Addendum No.2
to
CONSTRUCTION DOCUMENTS
for

June 2, 2025
2023159.00

NCISD New District Administration Building
21330 Valley Ranch Parkway
New Caney, TX. 77357
June 2, 2025

T-112-B2

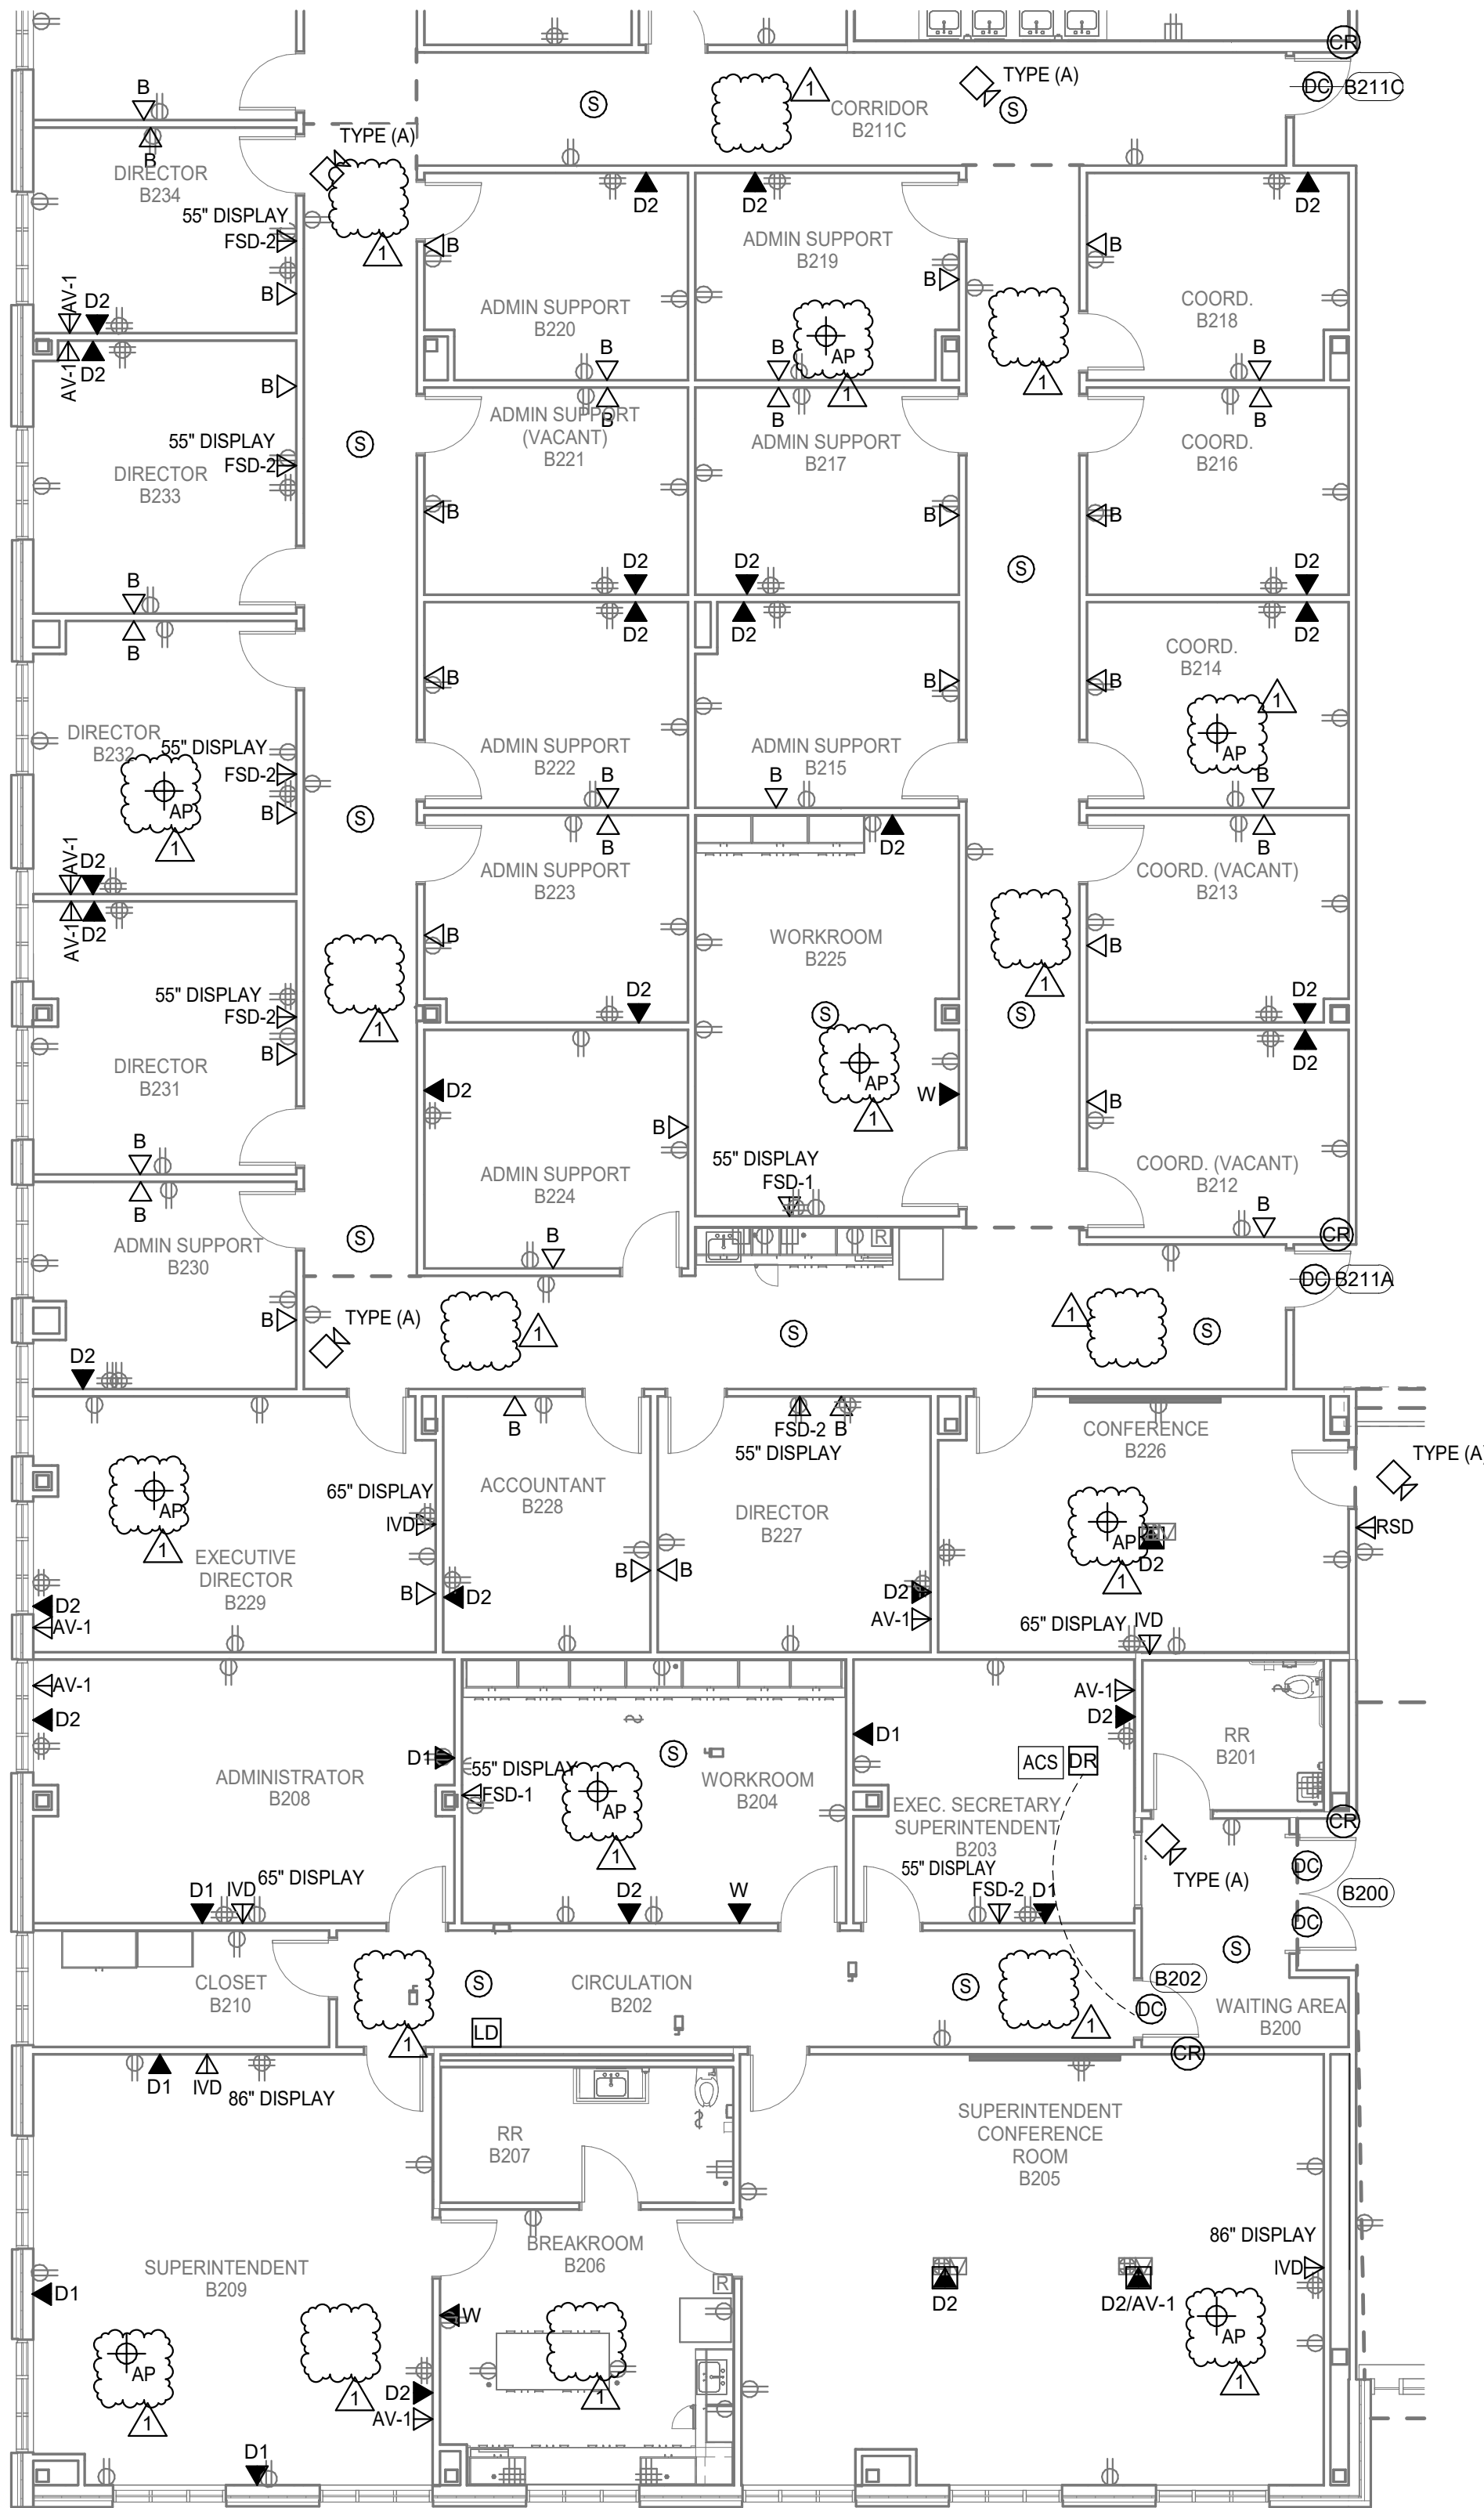
21. SHEET T-112-B2 - TECHNOLOGY SECOND FLOOR AREA - B2
 - a. Revised wireless access point 'AP' layout as shown.
22. SHEET T-113-C2 - TECHNOLOGY SECOND FLOOR AREA - C2

T-116-E2

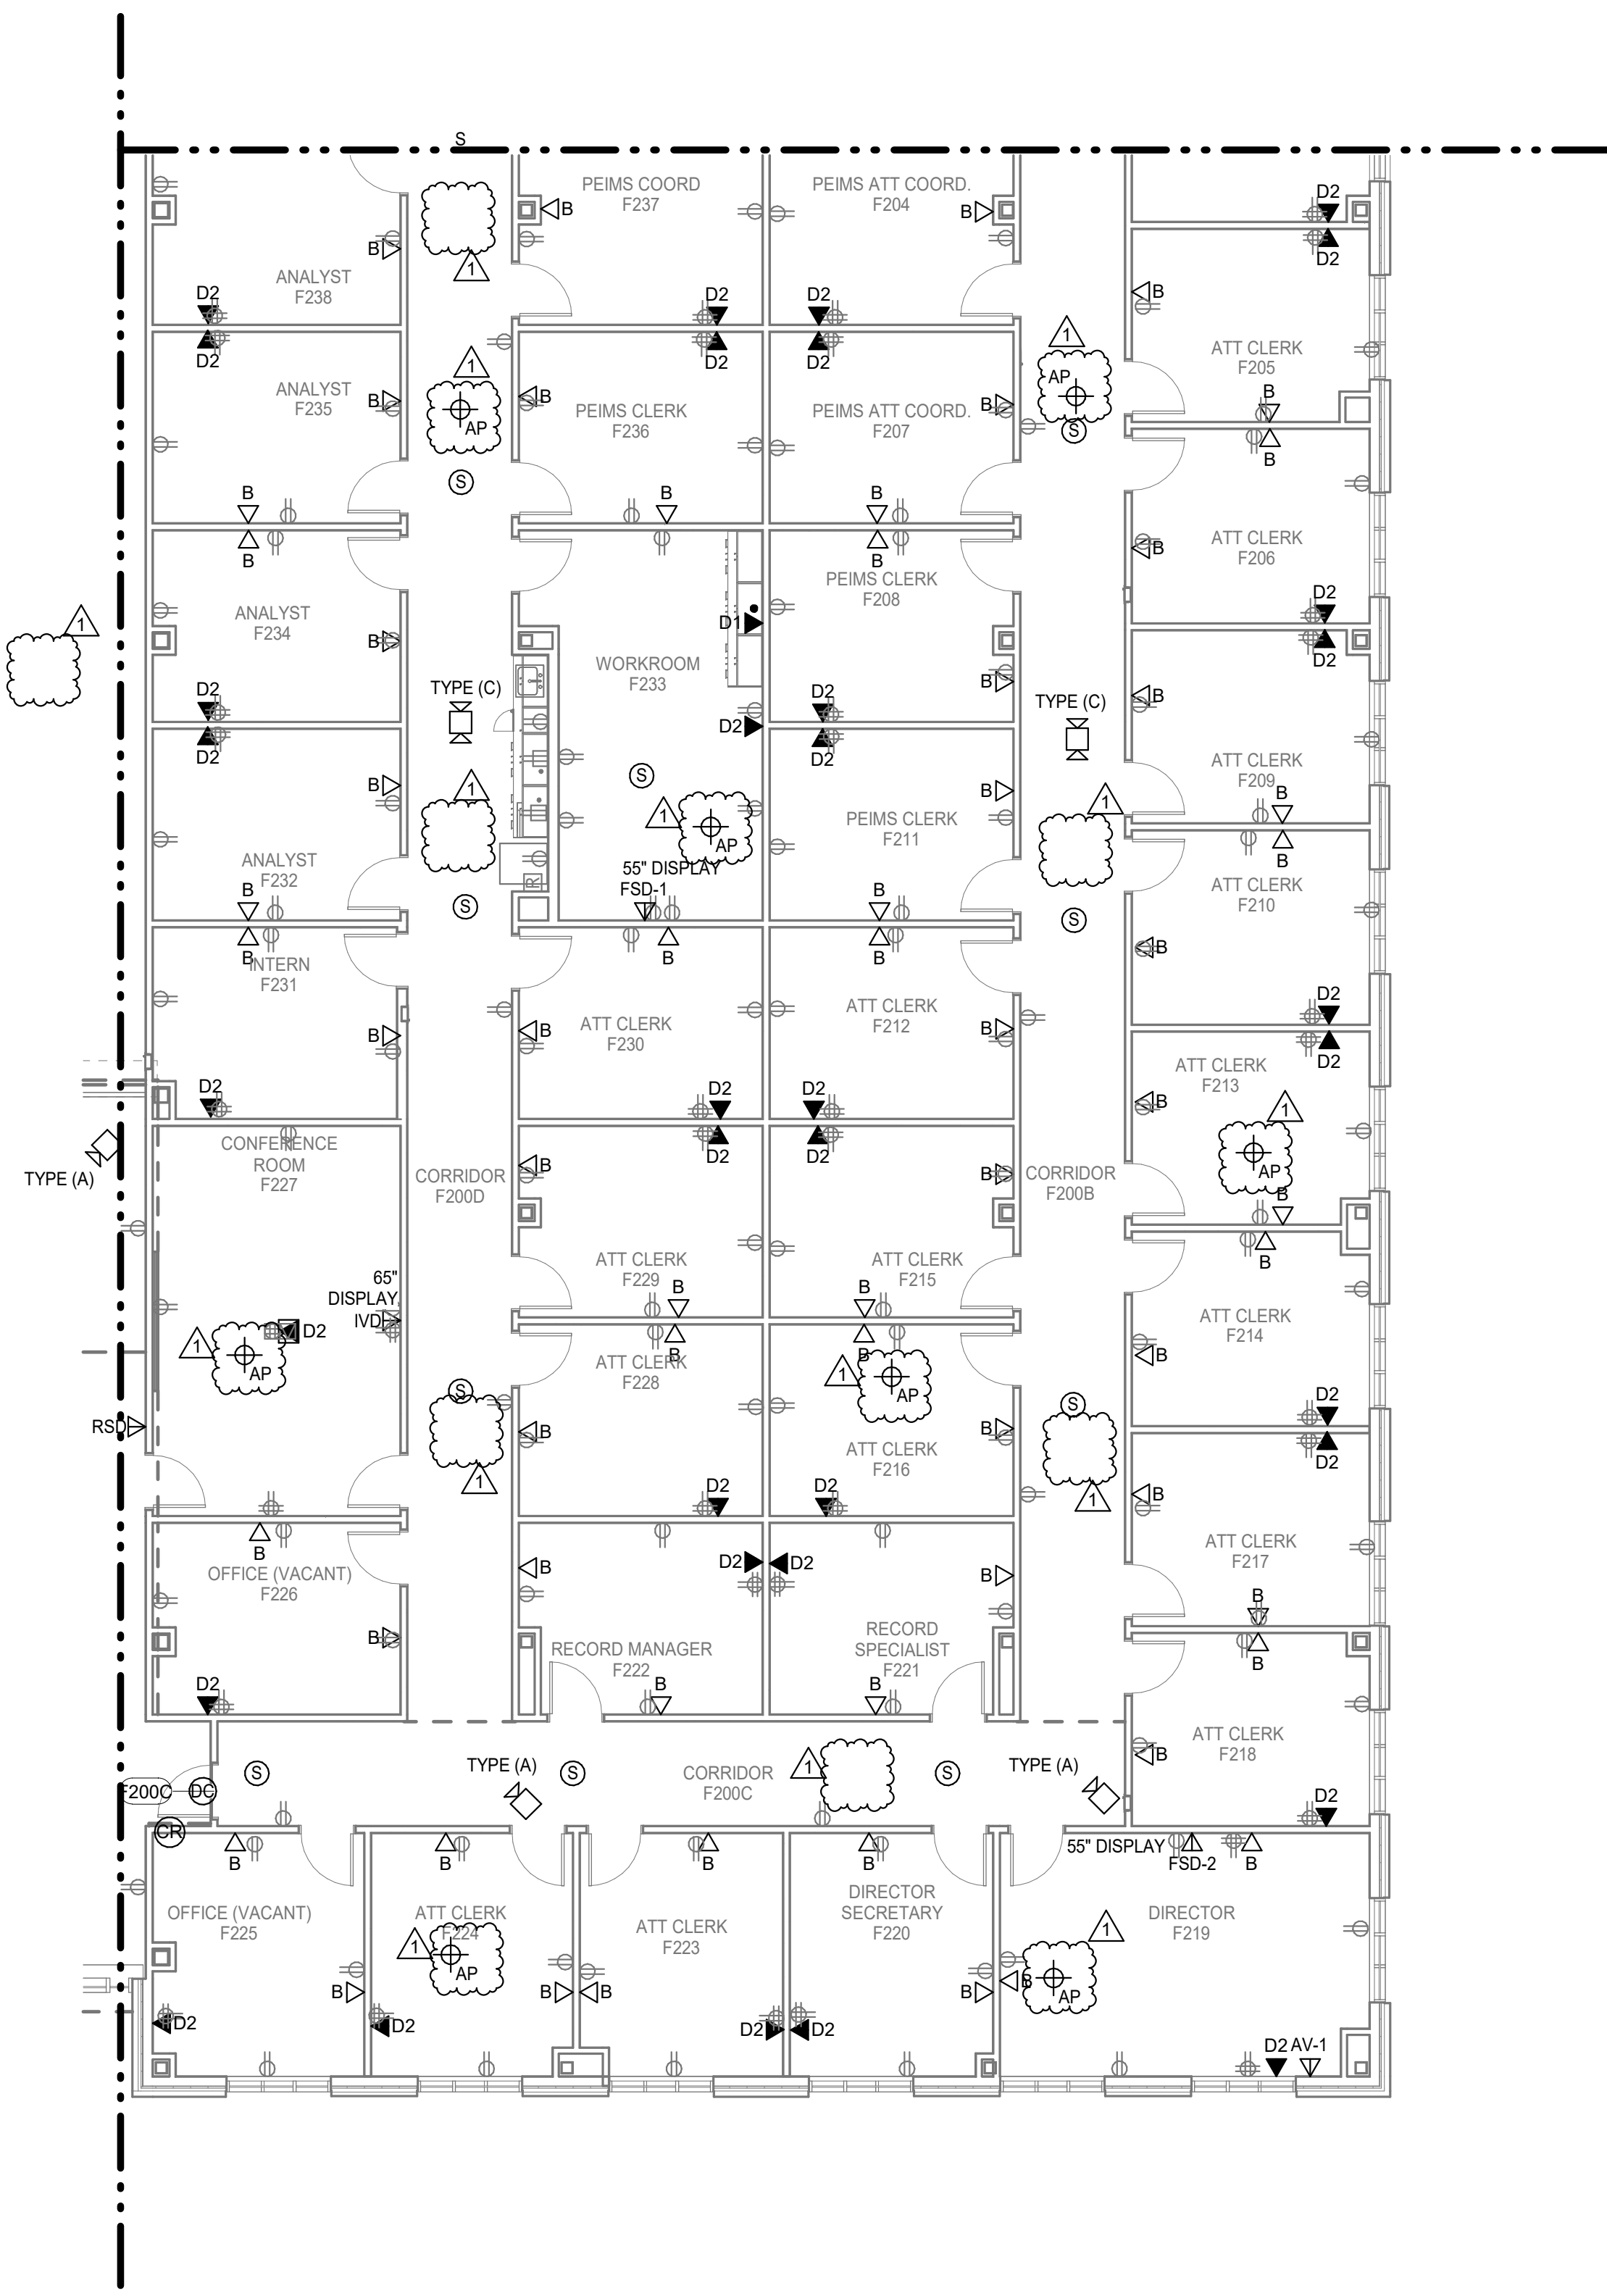
25. SHEET T-116-E2 - TECHNOLOGY SECOND FLOOR AREA – E2
 - a. Revised wireless access point 'AP' layout as shown.
26. SHEET T-117-F2 - TECHNOLOGY SECOND FLOOR AREA – F2

T-117-F2

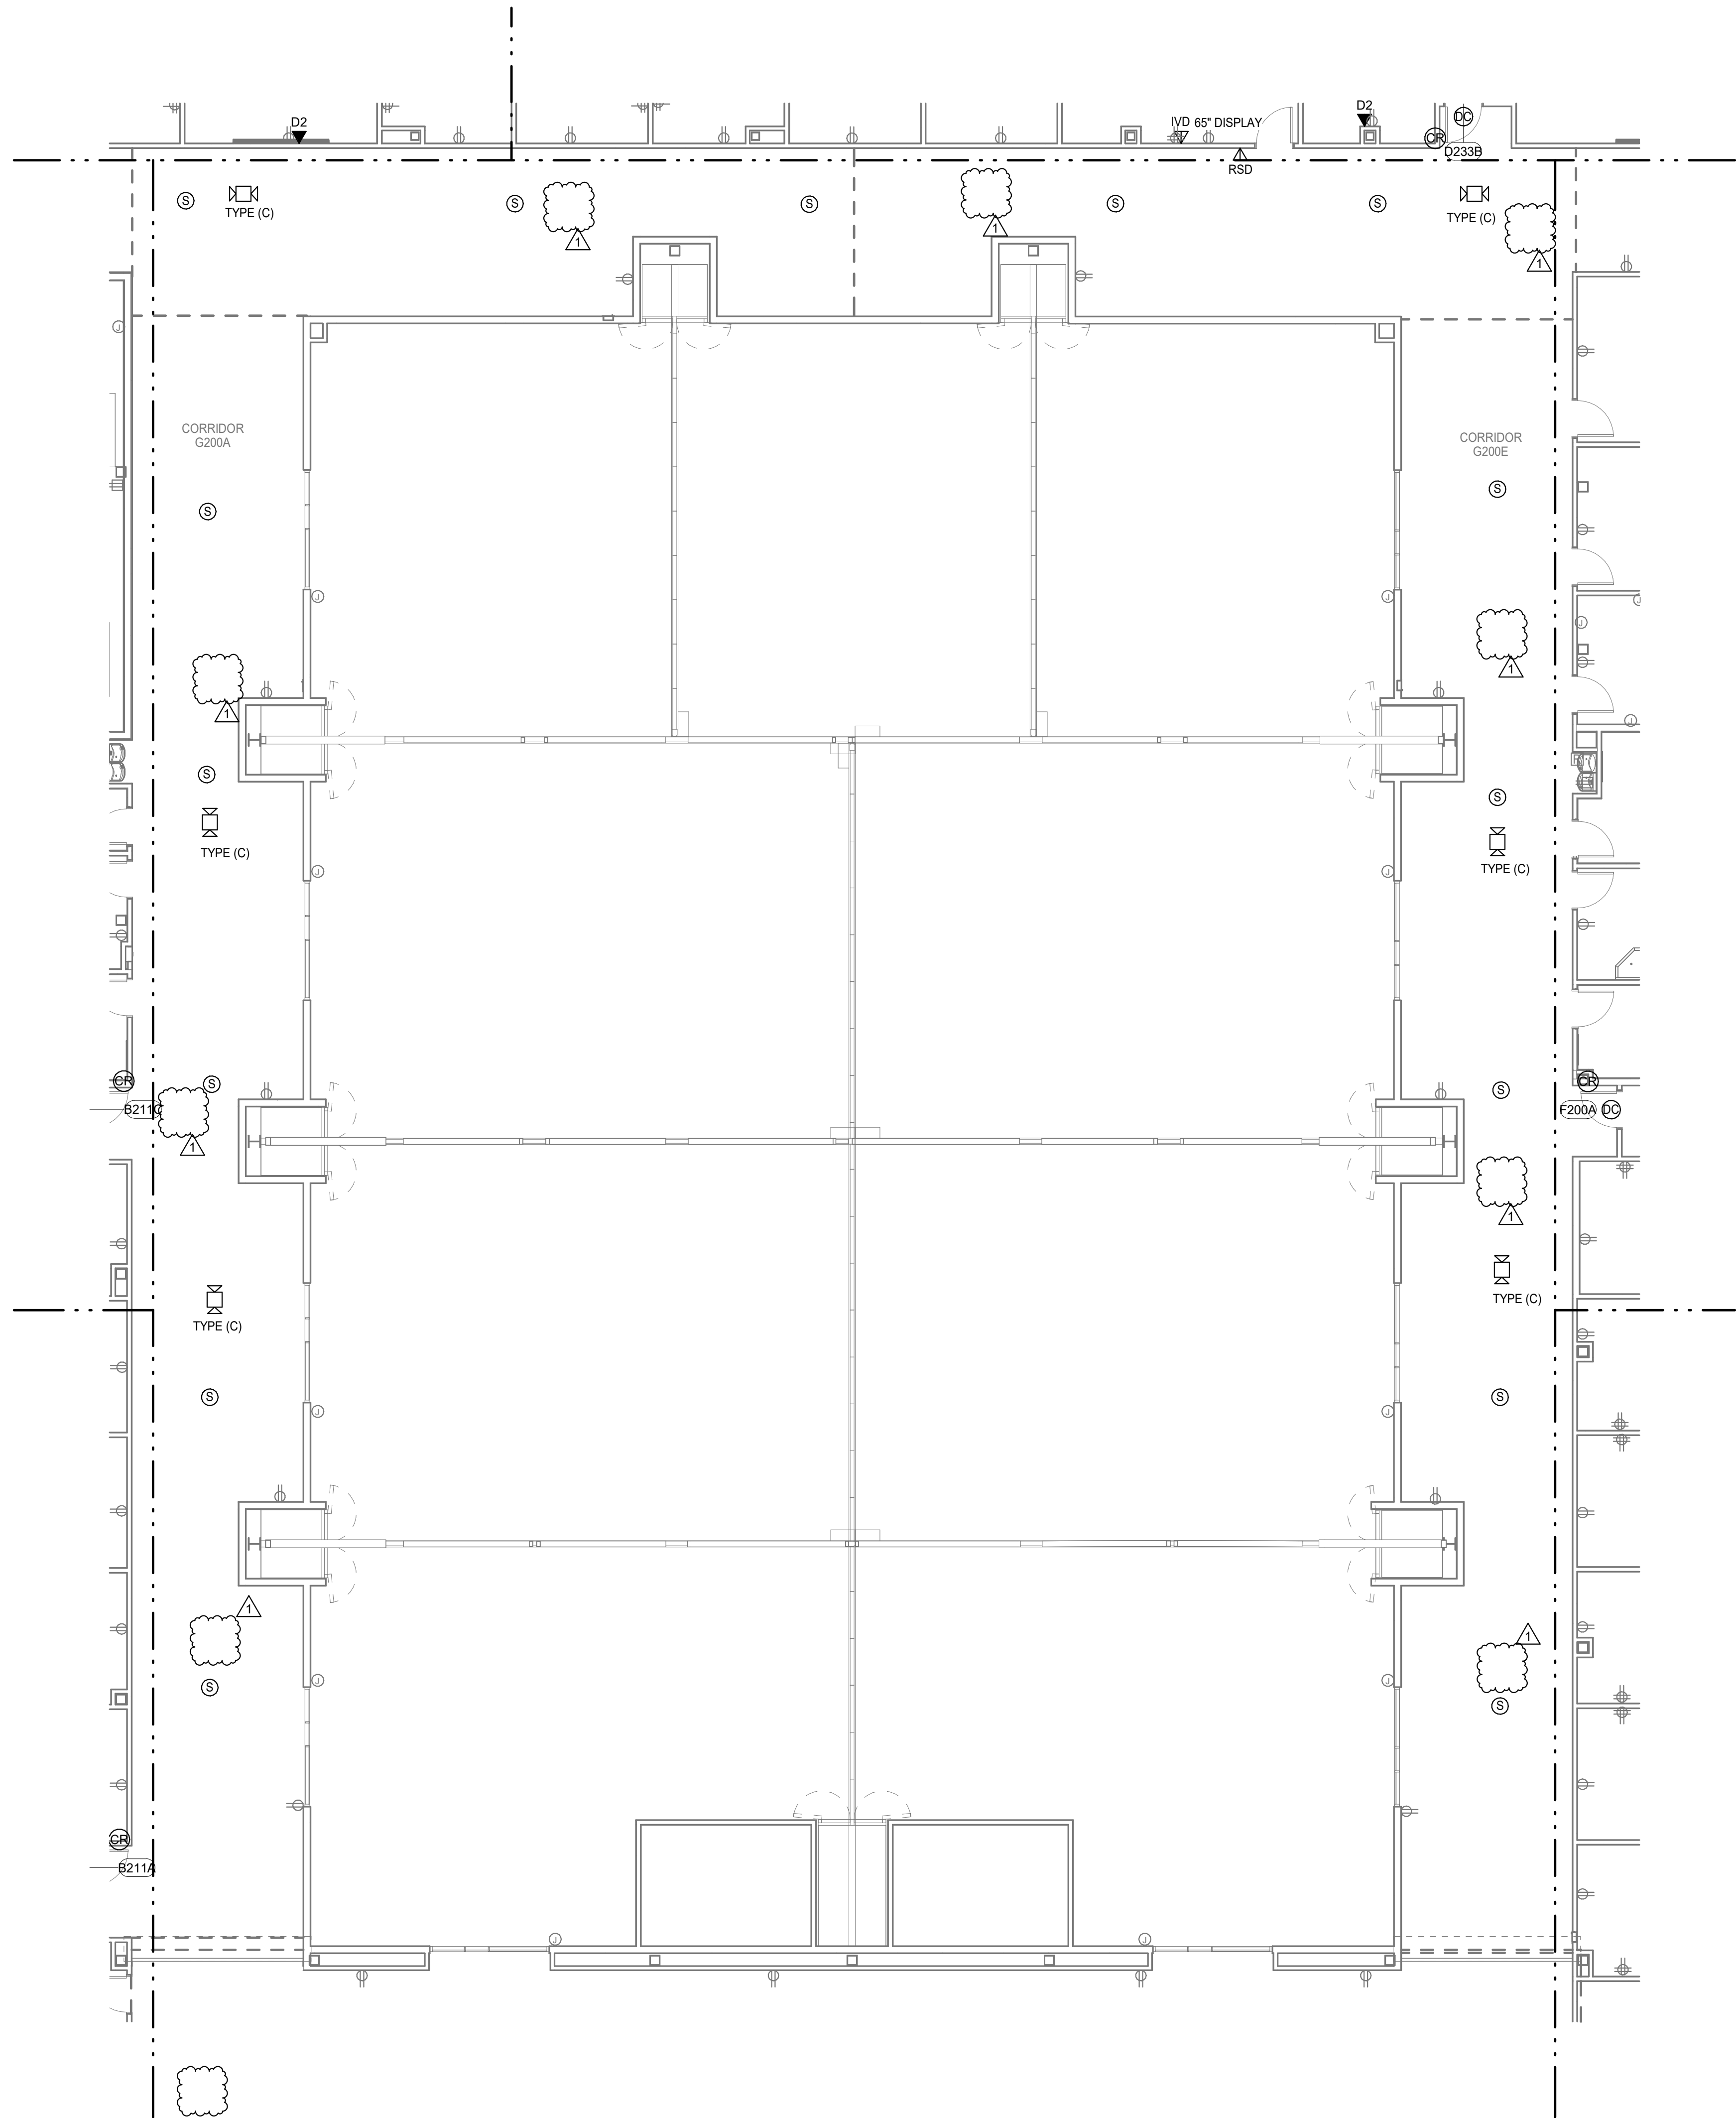
- a. Revised wireless access point 'AP' layout as shown.
27. SHEET T-118-G2 - TECHNOLOGY SECOND FLOOR AREA – G2
 - a. Revised wireless access point 'AP' layout as shown.
